# UNITED STATES PATENT AND TRADEMARK OFFICE

APPLICATION NO.	FILING DATE	FIRST NAMED INVENTOR	ATTORNEY DOCKET NO.	CONFIRMATION NO.
09/914,874	09/05/2001	Johann Michael Koehler	F-7129	6041

<b>Office Action Summary</b>	<b>Application No.</b> 09/914,874	<b>Applicant(s)</b> KOEHLER, JOHANN MICHAEL	
	<b>Examiner</b> Jyoti Nagpaul	<b>Art Unit</b> 1743

## DETAILED ACTION

Figure 1. Jiang Microfluidic Device

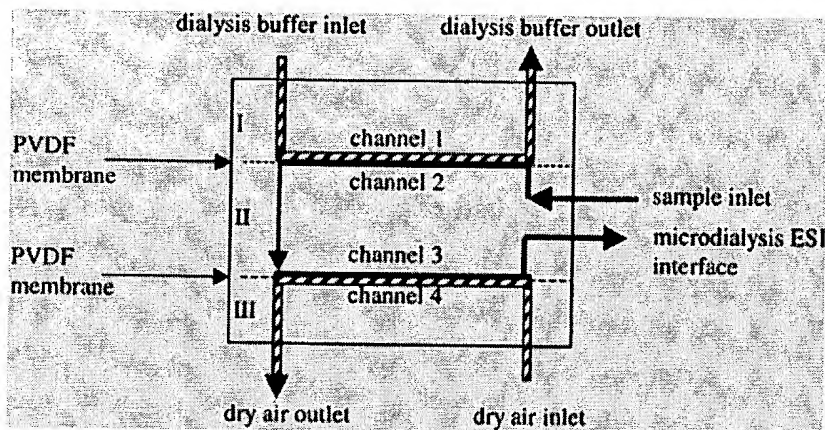
Jiang discloses a microfluidic device that includes a first substrate (I, see Figure 1) and a second substrate (III) wafer being engaged to one another in a common plane,

where a longitudinally extending channel (see figure 3) is inserted into one substrate wafer, The channel is captured by two passage openings (see Figure 1 or 3), which are passed through the substrate wafer. Filter elements (PVDF membrane, see Figure 1 or 3) are provided, and the passage openings are separated from the channel by a partially permeable sieve-like membrane. The membrane has transmission areas (see Figure 3) so that they prevent micro-beads and/or cells, which are introduced into the channel, from entering into the passage openings. The channel is provided with two further openings outside (see Figure 3) of the section captured by passage openings. The two openings is adapted to enable a loading and/or a displacement of the micro-beads and/or cells, provided above the section captured by a passage, by applying a fluidic pressure and further comprising means for temporarily closing at least one of the passage openings and one of the further openings. (Also refer to Figure below) Jiang discloses plurality of substrate wafers that include two passage openings each and linearly fluidically interconnected by channels. A recitation of the intended use of the claimed invention must result in a structural difference between the claimed invention and the prior art in order to patentably distinguish the claimed invention from the prior art. If the prior art structure is capable of performing the intended use, then it meets the claim. In a claim drawn to a process of making, the intended use must result in a manipulative difference as compared to the prior art. See *In re Casey*, 152 USPQ 235 (CCPA 1967) and *In re Otto*, 136 USPQ 458, 459 (CCPA 1963).
